Re: Indian Point Unit 2
Docket 50-247

NL-07-038

**SUBJECT: Proposed Changes to Indian Point 2 Technical Specifications
Regarding Diesel Generator Endurance Test Surveillance**

ATTACHMENT ONE TO NL-07-038

**TABLE ONE
COMPARISON OF VARIOUS DIESEL GENERATOR LOADING VALUES**

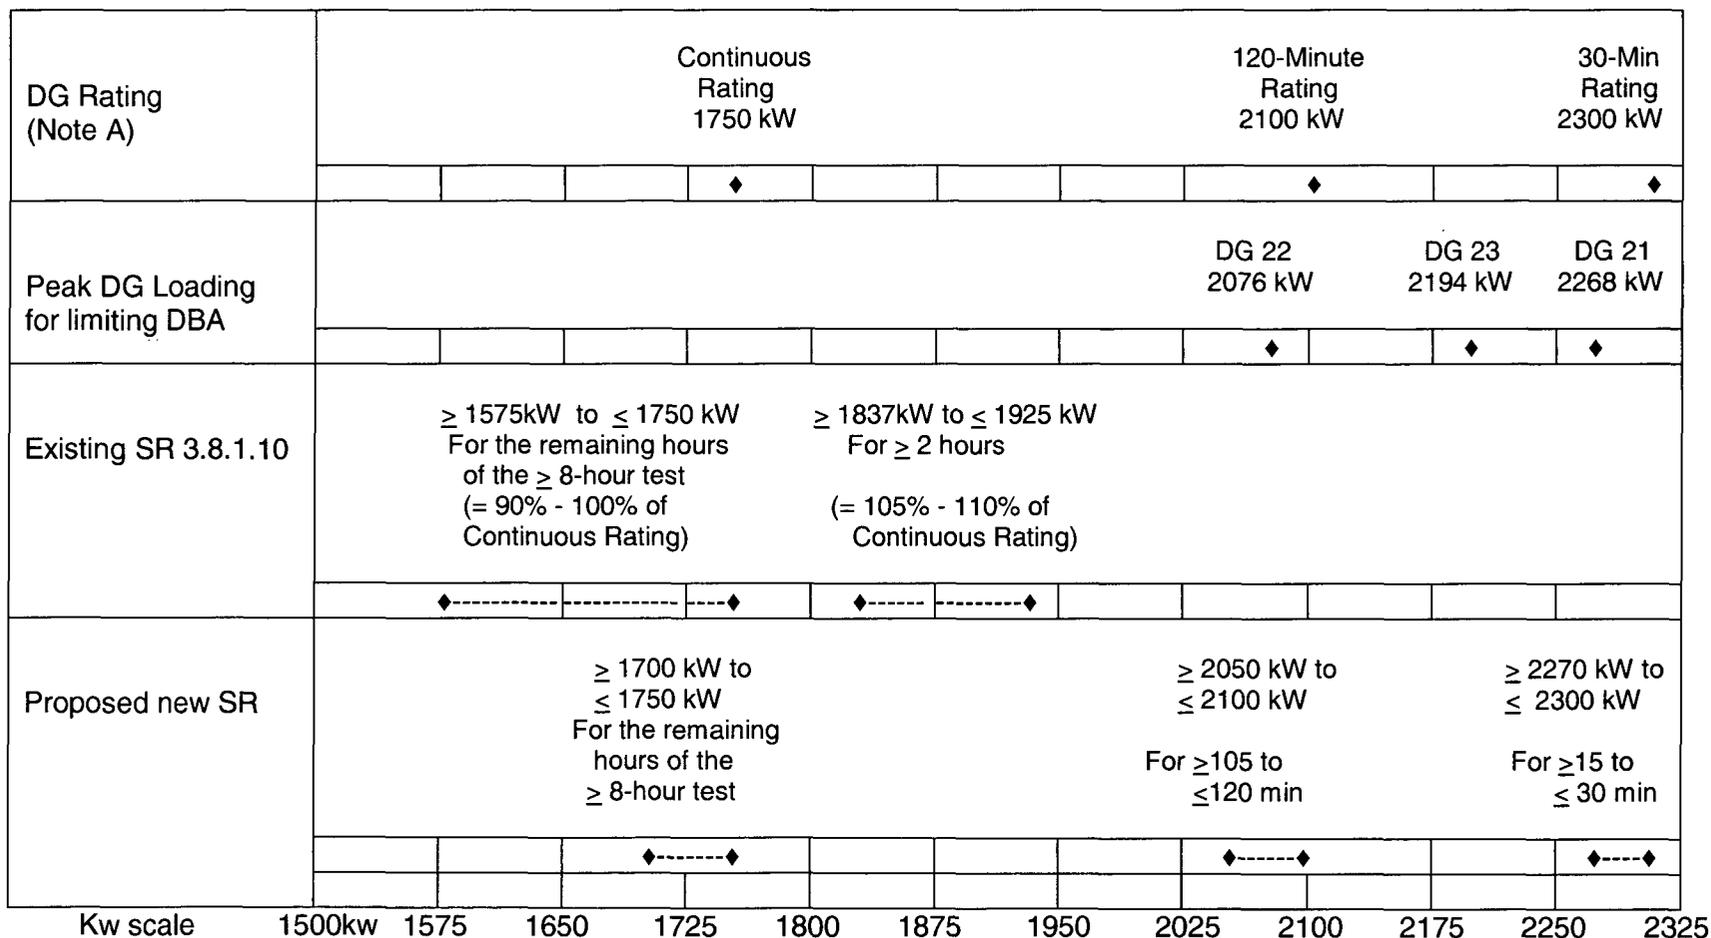
During NRC inspection activities described in Reference 1, questions were raised regarding the adequacy of the load ranges specified in ITS SR 3.8.1.10 to demonstrate the capability of the DGs to operate at the peak loading conditions identified in plant safety analyses for the limiting design basis accident (DBA). As a result Entergy acknowledged the need to submit a license amendment request to establish new load ranges that would bound the peak accident loads. Entergy is proposing to establish load ranges based on the diesel ratings previously described in amendment 153, and Entergy has verified that the proposed new load ranges bound the peak accident loads. The values for the peak accident loads are included on Table One, which provides a comparison of the various DG loading values discussed in this section.

Note A: These rating are based on limitations imposed on the engine portion of the DG which are more limiting than the rating of the generator portion of the DG, which is rated for continuous operation at 2875 KVa.
